Modification Recommended Service Note

N8923A - Autoranging System DC Power Supply, 500V, 30A, 5000W, 208 VAC

Serial Numbers: DE14290000 - DE15369999 without manufacturing ID Version "B"

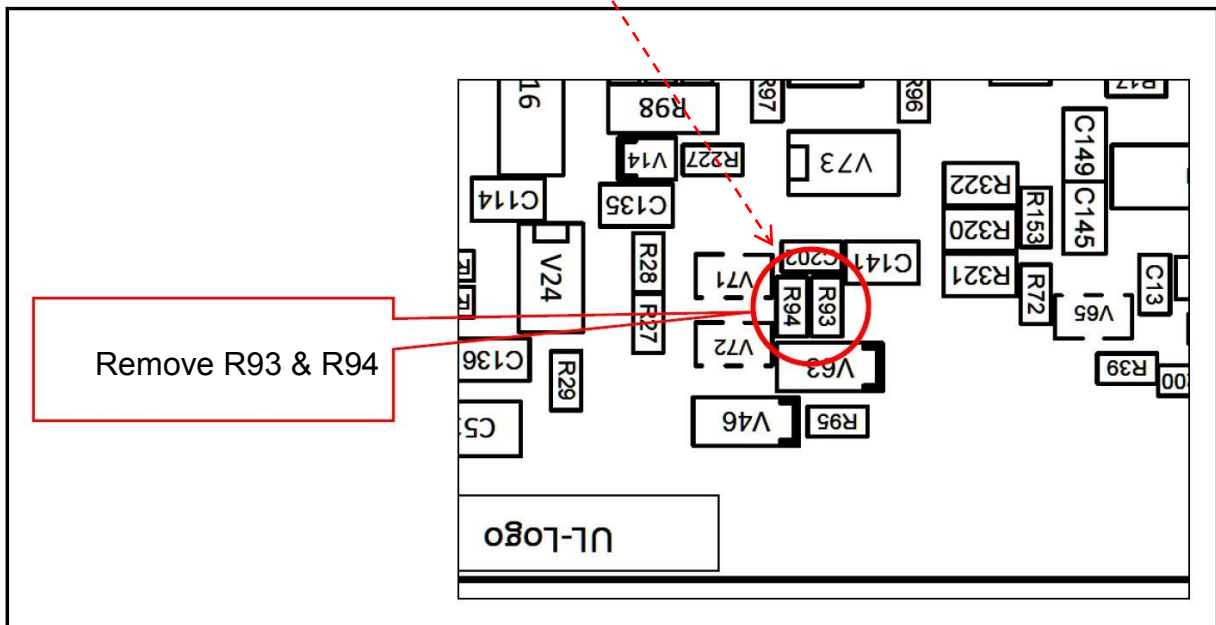
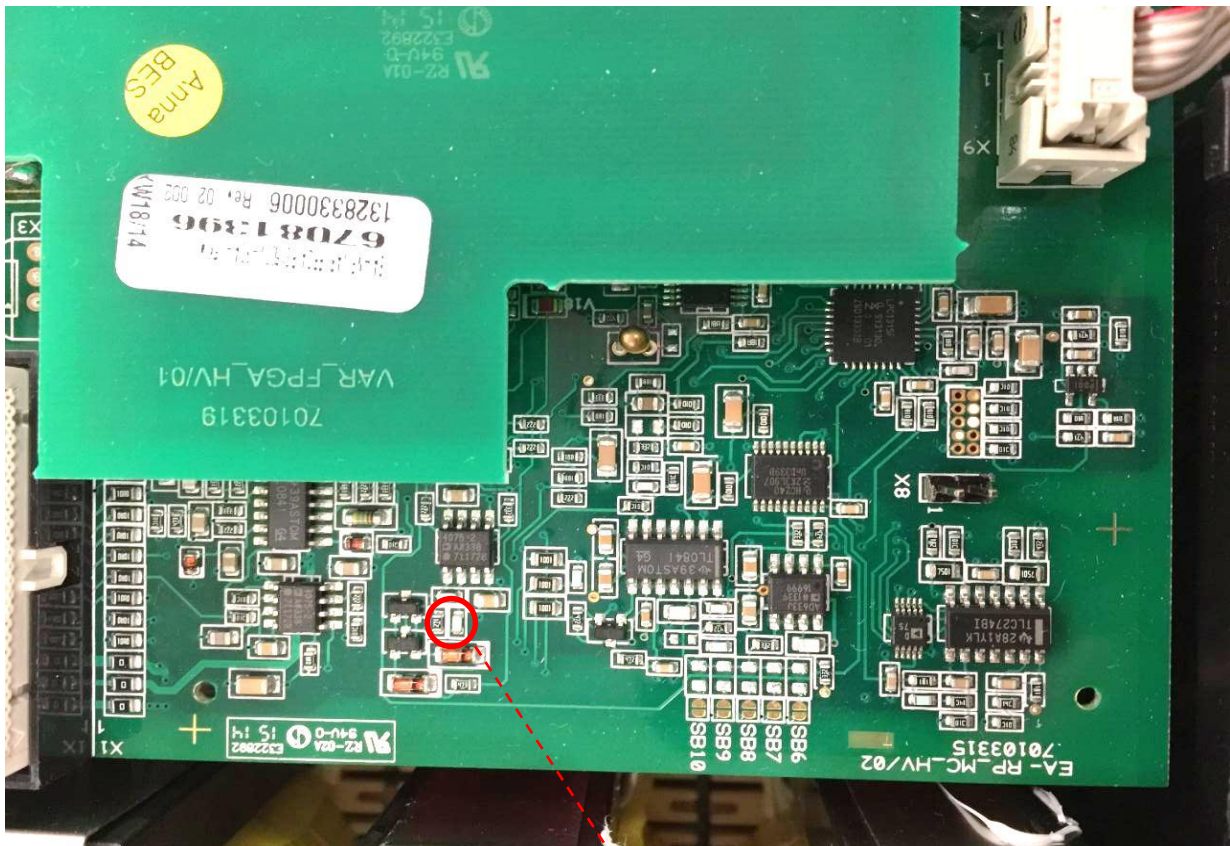
Removal of two (2) surface mount resistors, R93 and R94, will correct this problem:

- 1) Remove acMains cable from power source.
- 2) Wait 5 minutes
- 3) Remove top cover from instrument.
- 4) In the 5kW units (viewed from the front of the unit), a small SMT assembly located at the right-rear of instrument will be readily visible (see below):

In the 10kW & 15kW units; although found in the same location, a black plastic cover will have to be removed to gain visibility and access to the SMT assembly. Plastic cover snaps-on and can be removed with a small screwdriver.

5) SMT resistors R93/94 are located in red circle shown below:

Suffix "B" added

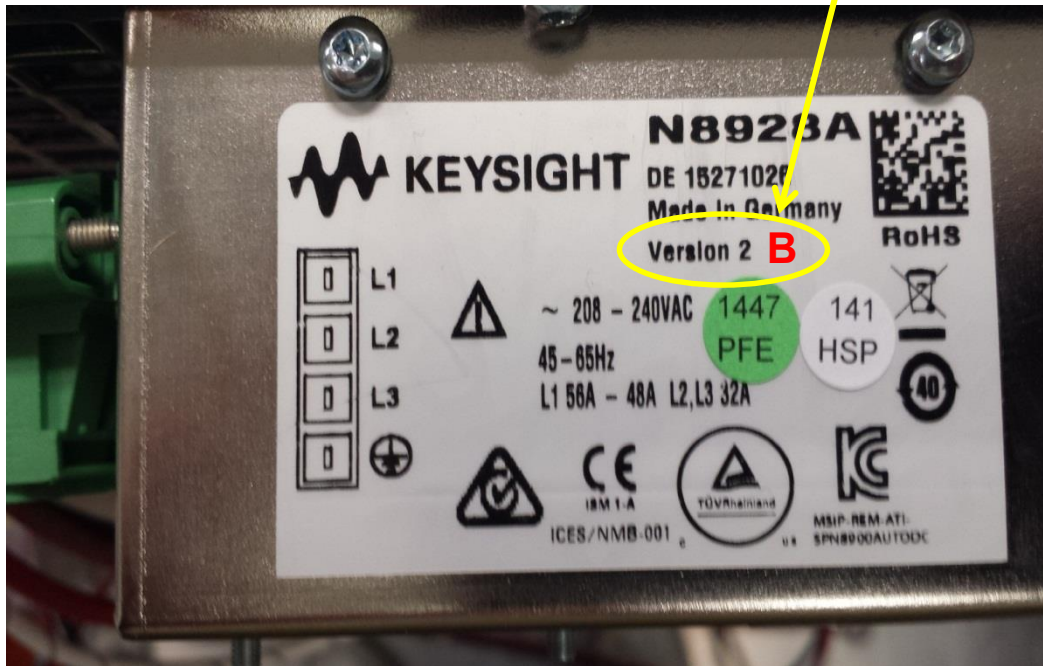
7) On the acMains label, on the rear of the instrument; use an indelible marker, to add the suffix letter "B" after the Version ID. This will assist in the tracking of modified instruments.
